# COLLINS RADIO COMPANY

## EQUIPMENT TYPE KWS-1

2A

SUBJECT: /A. USE OF CRYSTAL MICROPHONE WITH KWS-1

FIGURE | Mounting of component on terminal strip

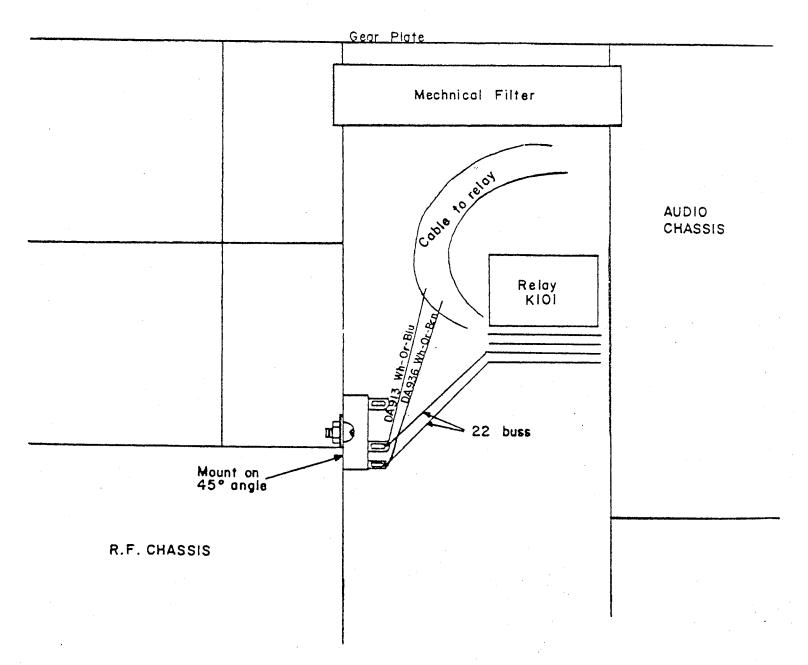
It has been discovered that some arcing is taking place at contacts 4 and 5 on the voice operate relay, KlOl, in the KWS-1. To prevent this arcing and increase the life of the relay contacts an arc suppression filter has been incorporated in production of the exciter effective with serial number 695. It is recommended that this filter be installed on all units below the above serial number and may be accomplished as described below.

- l. Mount resistor R246, 100 ohm l watt  $\pm$  10% (CPN 745 3310 00) and capacitor C315, .01 mfd 500V (CPN 913 1188 00) on tie point (CPN 306 2230 00) as shown in Figure 1. Do not solder.
- 2. Mount above assembly under existing screw which festens shir i to RF chassis as shown in Figure 2.
- 3. Remove DA936, white with orange and blue tracers, wire from terminal 5 of KlOl and connect to tie point assembly as shown in Fig. 2.
- 4. Remove DA913, white with orange and brown tracers, wire from terminal 4 of KlOl and connect to tie point assembly as shown in Fig. 2.
- 5. Connect terminals 4 and 5 of KlOl to the tie points using #22 buss wire (CPN 421 2220 00) as shown in Figure 2. Solder all connections.
- 6. Replace bottom plate onto exciter.
